Response to Examining Authority's Second Written Questions (WQ2) A428 Black Cat to Caxton Gibbet Improvement Scheme

Deadline 4: 4th November 2021

APPENDIX 1: POTENTIAL INTERFACES WITH VALUE MANAGED DESIGN

Figure 3 - Potential engineering interaction locations between the Scheme and EWR Project Route Alignments 1, 2 and 6 at Roxton Road (included in [AS-011])

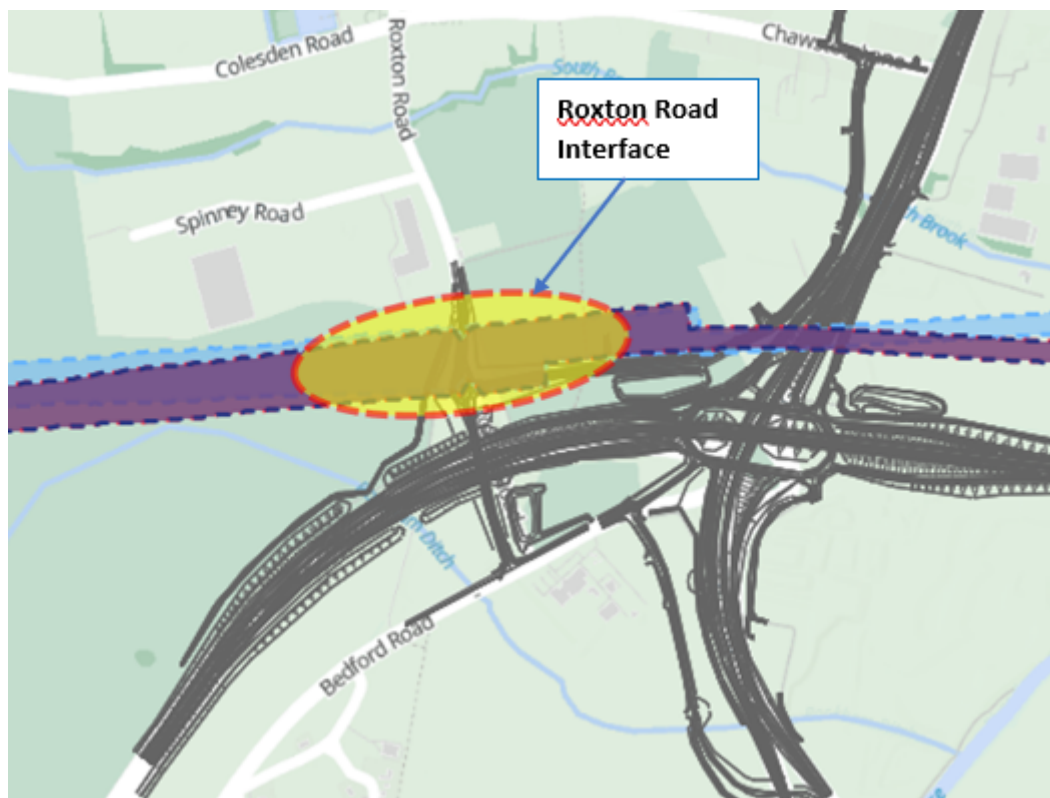
- 3.2.1. In this area it is presently anticipated that the EWR alignment would be supported by a ~10 m high embankment at the intersection with Roxton Road. Due to track geometry constraints, the present view of EWR Co in respect of the NSC design is that it would not be possible to maintain Roxton Road on its current alignment by rerouting it over or under the EWR alignment. Therefore, a diversion of Roxton Road would be proposed as part of the EWR Project, which would connect Roxton Road from the north to Roxton Road Link South after passing beneath EWR through a new underbridge.

- 3.2.2. To the west of Roxton Road, Route Alignments **1**, **2** & **6**, whether or not VM is adopted, would continue to run on an embankment. This would pass through the location of a large borrow pit proposed by the Scheme. The interface between these works would require appropriate phasing through construction and a coordinated environmental strategy post-construction. It would also be beneficial to the EWR Project for the Scheme to optimise the working of the borrow pit to minimise or avoid permanent excavations beneath the proposed footprint of the earthworks associated with Route Alignments **1**, **2** & **6**.

Figure 4 - Potential engineering interaction location between the Scheme and EWR Project Route Alignments 1, 2 and 6 at the Black Cat Junction (included in [AS-011])

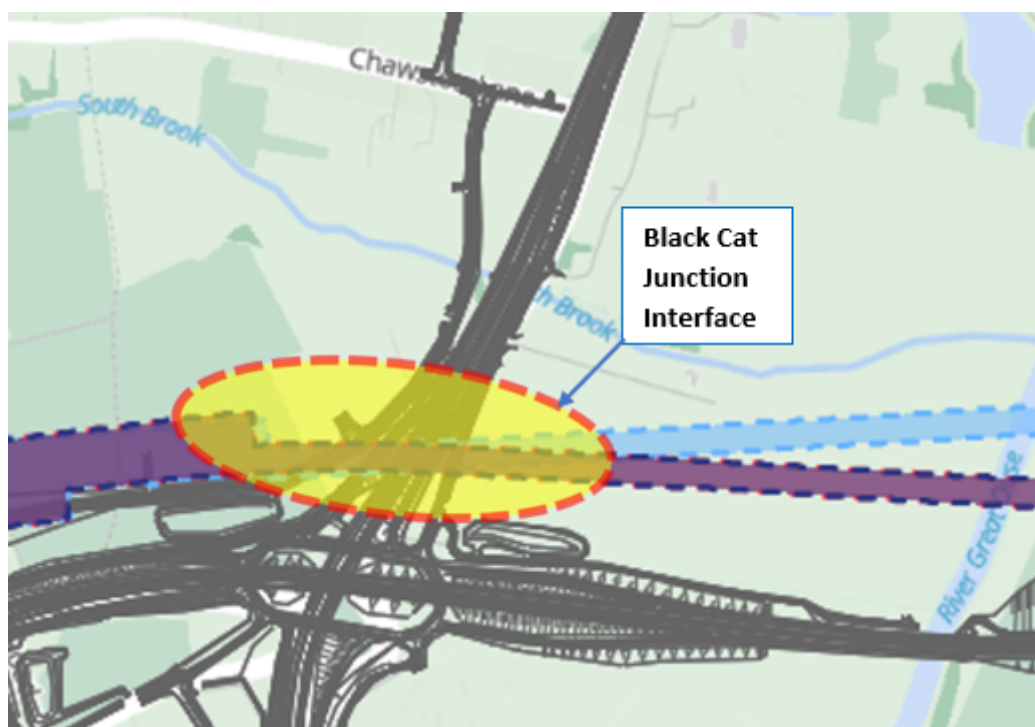
- 3.3.1. The NSC design proposes that Route Alignments **1**, **2** & **6** would pass over Black Cat Junction on a viaduct, which would avoid the remodelling of any major roads in this area (either existing, or those remodelled as part of the Scheme) but may require modification of some local road infrastructure such as Roxton Road. This is subject to design development and EWR Co is seeking to minimise impact on the A428 Scheme and other receptors.

- 3.3.2. While the viaduct is subject to ongoing detailed design work, keeping the EWR Project footprint to a minimum would reduce the potential for interactions with the Scheme's proposals.

- 3.3.3. To the east of Black Cat Junction, the NSC proposal is for Route Alignments **1**, **2** & **6** to be elevated on a viaduct passing over a borrow pit proposed to be utilised by the Scheme. The interface between these works would require appropriate phasing through construction and a coordinated environmental strategy post-construction. It would also be beneficial to the EWR Project for the Scheme to use the borrow pit in a way that minimises or avoids permanent excavations that would adversely affect the foundations of the viaduct proposed by the EWR Project.

Figure 7 - Potential engineering interaction locations between the A428 Scheme and EWR in Area B (Alignments 1, 2 and 9) (included in [AS-011])

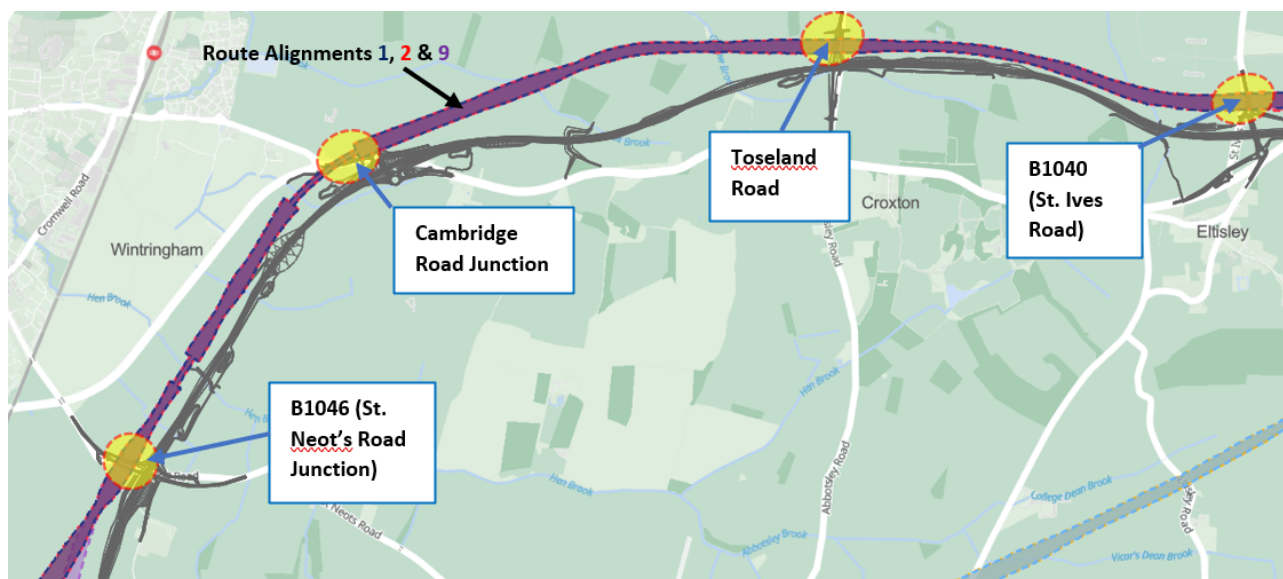
5.1.1. Figure 7 below illustrates the potential engineering interaction locations between the A428 Scheme and EWR in Area B.

Figure 9 - Potential engineering interaction location between the A428 Scheme and EWR at the Cambridge Road Junction (Route Alignments 1, 2 and 9) (included in [AS-011])

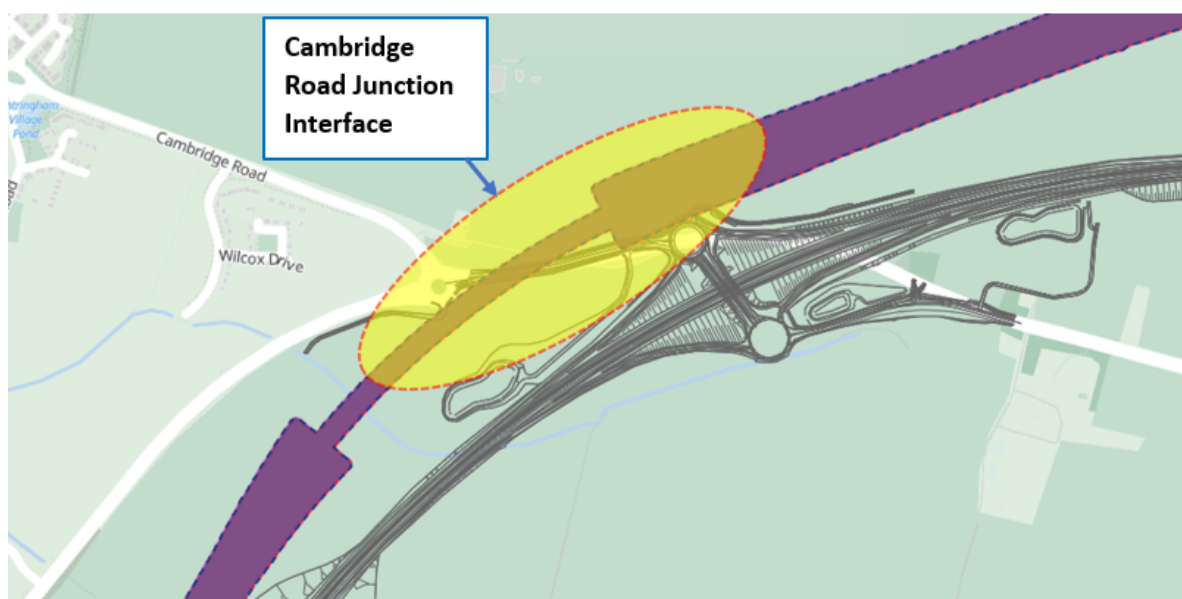
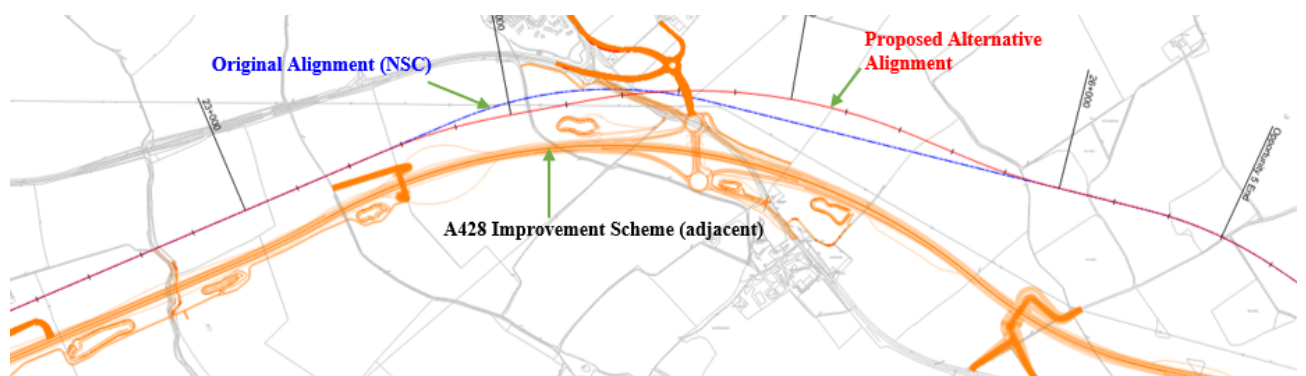
- 5.3.2. The NSC designs at Cambridge Road Junction, as presented in [REP1-074] and [AS-011], feature high embankments and a 600 m long viaduct over the north roundabout access road proposed by the Scheme. Whilst this would avoid realigning new (as proposed by the Scheme) or existing highways, the scale of the earthworks required for the EWR Project would mean that there would remain interaction with the Scheme, including the requirement to construct earthworks as part of the EWR Project within areas presently proposed by the Scheme for soil storage.

- 5.3.3. In developing the designs following the 2021 Non-Statutory Consultation, EWR Co is considering a lower VM Alignment for Route Alignments 1, 2 and 9. This could lower the EWR alignment into a shallow cutting in this location; thereby reducing earthwork requirements and avoiding the need for a viaduct. The EWR alignment would also be realigned horizontally to provide greater clearance to the existing A428 roundabout, avoid a soil storage area proposed by the Scheme and minimise overhead powerline diversions in the area.

- 5.3.4. However, in this scenario, the Scheme's proposed access road which connects to the northern roundabout of the Cambridge Road junction, would require realignment and the introduction of an overbridge, as part of the EWR Project.
- 5.3.5. If this Value Management opportunity is progressed by EWR Co., there could well be considerable benefit to the construction programme of the EWR Project and the Scheme (either in construction or to minimise disruption in operation) if the Scheme's proposed access road which connects to the northern roundabout of the dumbbell junction were realigned to the location required by the EWR Project and the underbridge proposed as part of the EWR Project was built at the same time as the Scheme's proposed access road.

Figure 11 - Potential engineering interaction location between the A428 Scheme and EWR at Toseland Road (Route Alignments 1, 2 and 9) (included in [AS-011])

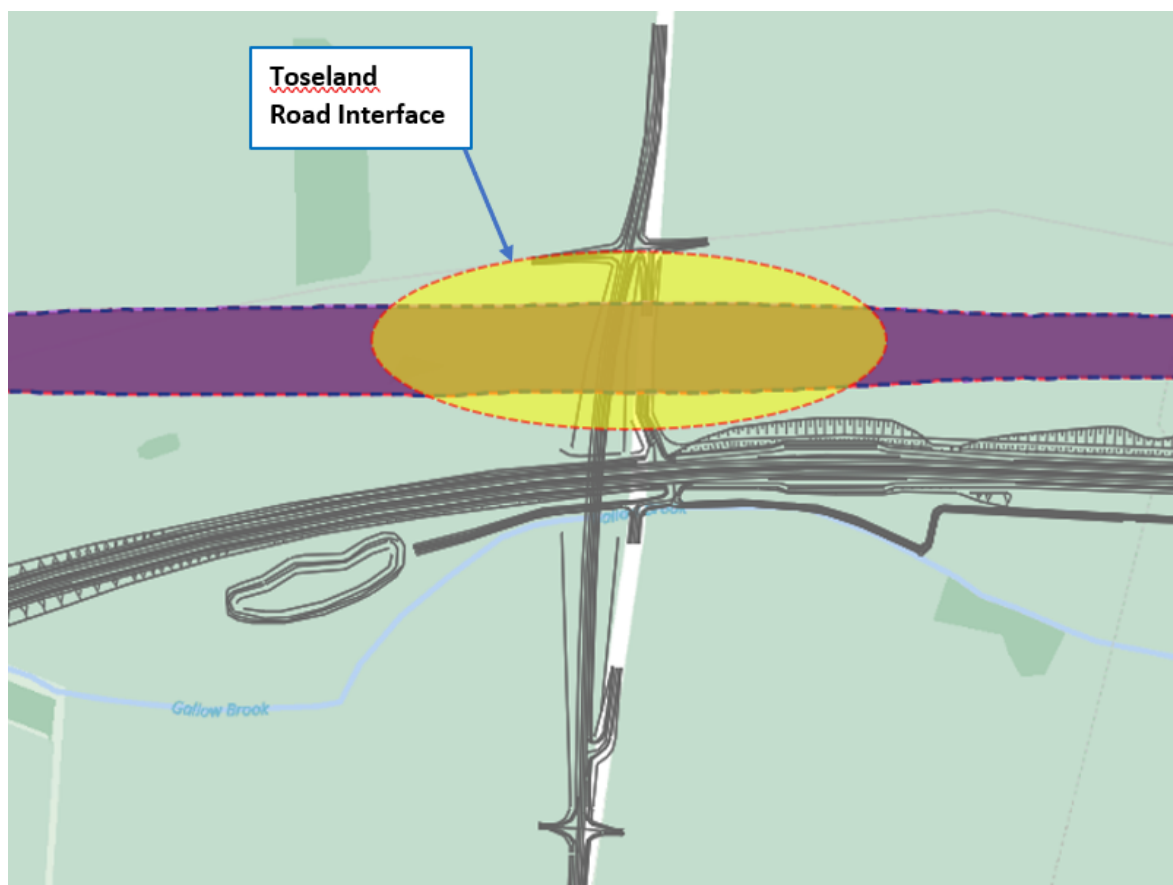
- 5.4.2. At Toseland Road, the emerging VM Alignment design currently being considered does not deviate from the NSC design for Route Alignments 1, 2 or 9.

- 5.4.3. In this location, the NSC design proposes that Route Alignments 1, 2 and 9 would be in a cutting passing underneath the Scheme's realigned Toseland Road. It is anticipated that a highway overbridge at the intersection would be introduced, which it is not presently expected would require any deviation to the vertical or horizontal alignment of the Scheme's realigned Toseland Road.

- 5.4.4. There could be considerable benefit to the construction programme of the EWR Project and the Scheme (either in construction or to minimise disruption in operation) if the Toseland Road highway overbridge proposed as part of the EWR Project was built at the same time as the highway realignment proposed by the Scheme.

- 5.4.5. In addition, if the NSC design were pursued it is anticipated that the emergency access and maintenance road proposed by the Scheme would need to be realigned to some degree (horizontally and/or vertically) by the EWR Project. This is due to Route Alignments 1, 2, and 9 crossing perpendicular to, and severing, the Scheme's proposed

northern carriageway emergency access. If this were to be relocated by the Scheme prior to implementation there could be benefit to the construction programme of the EWR Project and the Scheme (either in construction or to minimise disruption in operation).

Figure 12 - Potential engineering interaction location between the A428 Scheme and EWR at the B1040 St. Ives Road (Route Alignments 1, 2 and 9) (included in [AS-011])

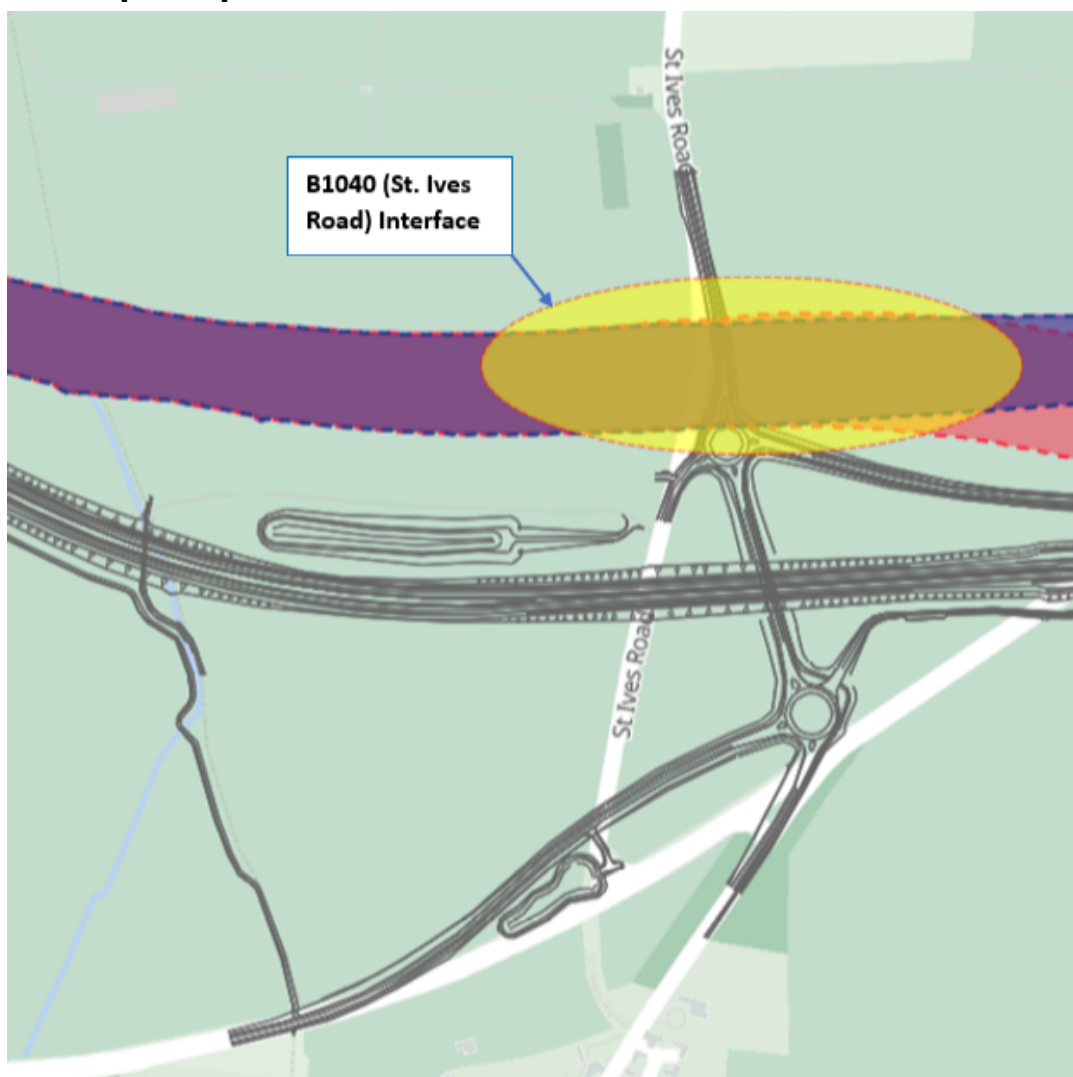
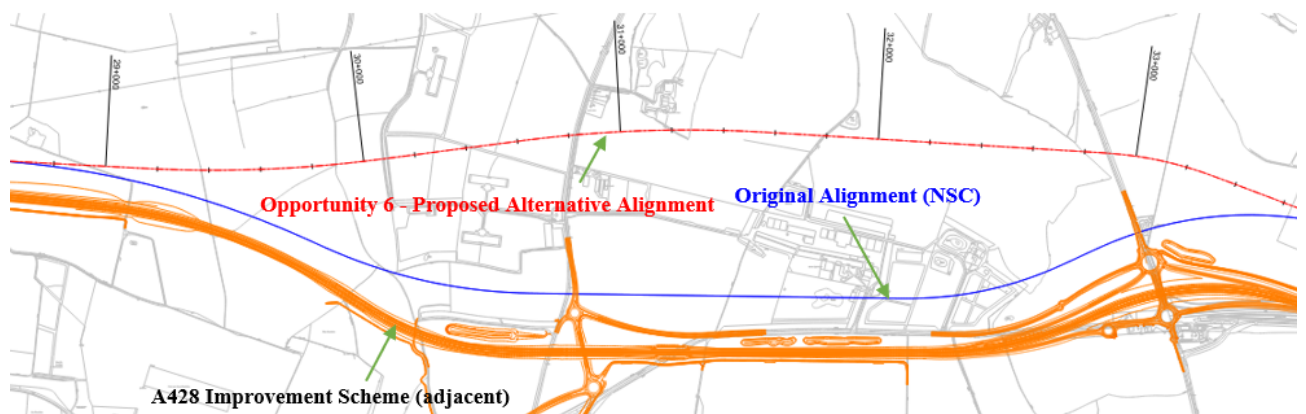
- 5.5.2. The NSC designs for Route Alignments 1, 2 and 9 feature high embankments and a rail bridge over the Scheme's realigned B1040 St Ives Road. If adopted, this would result in

an interaction between the EWR Project and the Scheme, due to the proximity of the EWR Project earthworks and the junction of the B1040 and A428. This would have several disadvantages for the EWR alignments, including decreased rail operational performance due to the track gradients required and the need to construct on a historic landfill site.

- 5.5.3. EWR Co is considering whether VM Alignments for Route Alignments 1 and 9 can be lowered to be closer to ground level. As a result, the realigned B1040 St Ives Road would need to be further realigned by the EWR Project to bridge over the EWR alignment. This would avoid the need for otherwise complex interactions between the EWR Project and the Scheme. Further, it is anticipated that the reduction in the height of the railway embankments proposed in the NSC design may lead to a lower visual impact and improved rail performance. The emerging VM Alignments would result in the permanent railway infrastructure associated with the EWR alignment falling outside the Order limits of the Scheme.

Figure 14 - Potential engineering interaction location between the A428 Scheme and EWR at the A1198 (Route Alignments 1, and 9) (included in [AS-011])

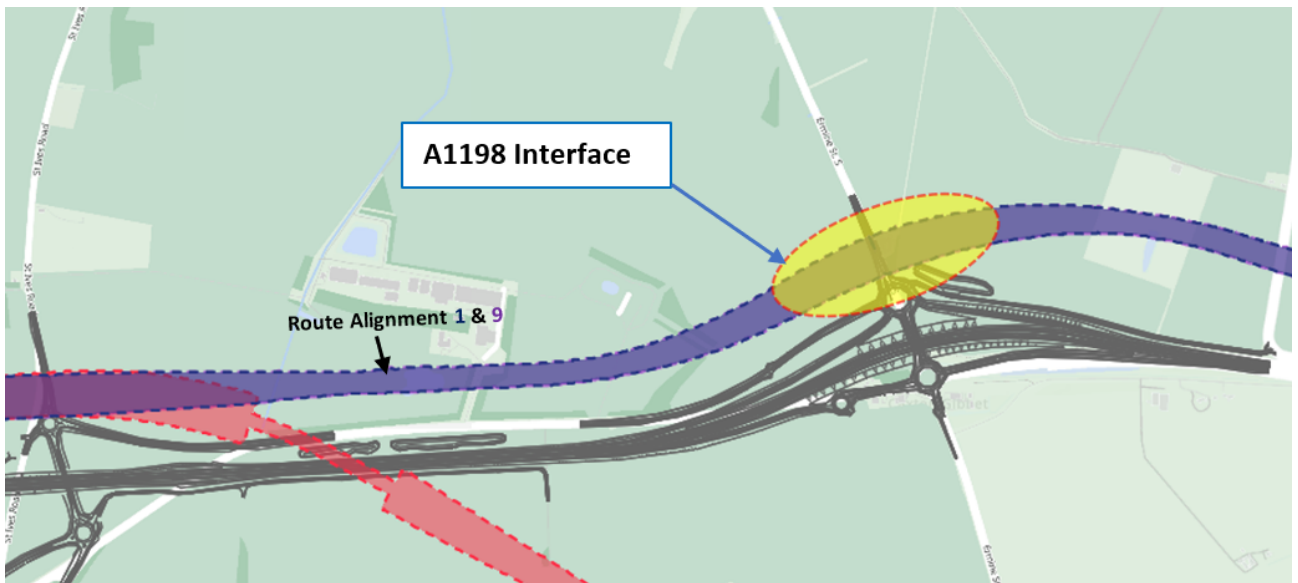
- 6.1.2. In the NSC design, it was currently envisaged that Route Alignments 1 and 9 would feature high embankments and a rail bridge over the Scheme's reconfigured A1198 Ermine Street South. This would result in interactions between the EWR Project and the Scheme, including the requirement for the EWR Project to carry out construction activities in the location of two borrow pits proposed by the Scheme. As a result of the design proposed at NSC to minimise interaction with the Scheme and the existing road network there would be several disadvantages for the EWR alignments and the surrounding area, including negative visual impacts, decreased rail operational performance and the requirement for the demolition of property.

- 6.1.3. In the emerging VM proposals (as illustrated in Figure 13), Route Alignments 1 and 9 would be moved away from the NSC designs and lowered to be closer to ground level. The A1198 Ermine Street South highway would be realigned by the EWR Project to

bridge over the EWR alignment. This would avoid the need for otherwise complex interactions between the EWR Project and the Scheme. Further, it is anticipated that the reduction in the height of the railway embankments proposed by the NSC design may lead to a lower visual impact and improved rail performance. In addition, the emerging VM Alignment design would allow for one of the Scheme's borrow pits to be avoided, while the footprint of the railway earthworks would also be reduced by being closer to existing ground level.
